Historic Architectural Review Commission Staff Report for Item 8

Meeting Date: May 24, 2022

Address: #1209 Royal Street

Description of Work:

2 DEMOLITION ELEVATION
 AD1.1 SCALE: 3/16" = 1'-0"

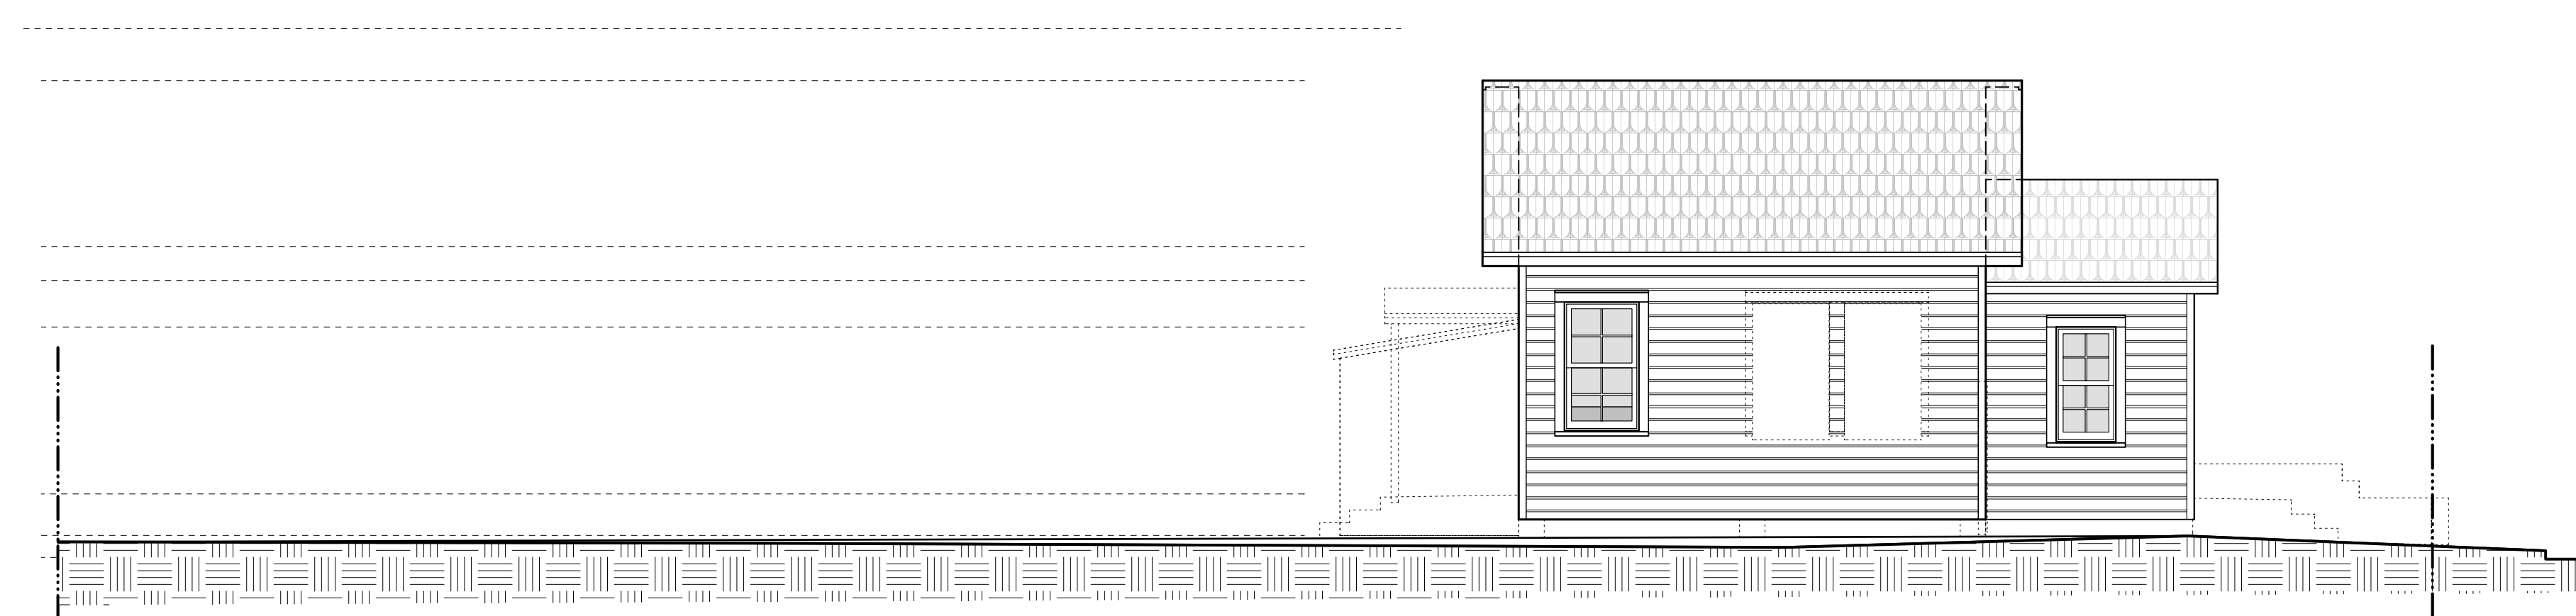
The Certificate of Appropriateness under review proposes the demolition of a shed addition at the rear of the house at 1209 Royal Street. The proposal also includes the removal of concrete stoops at the front and rear and low walls at the front and sides. Renovations and an addition to the historic house are under review as part of this application.

It is staff's opinion that the removal of the elements in question will not have a negative effect on the character of the surrounding neighborhood.

The elements in question are non-historic.

The elements under review for demolition have not acquired historic significance that is important to the site or surrounding district.

It is staff's opinion that the elements in question will not qualify as contributing elements to the site or to the historic district in the near future.
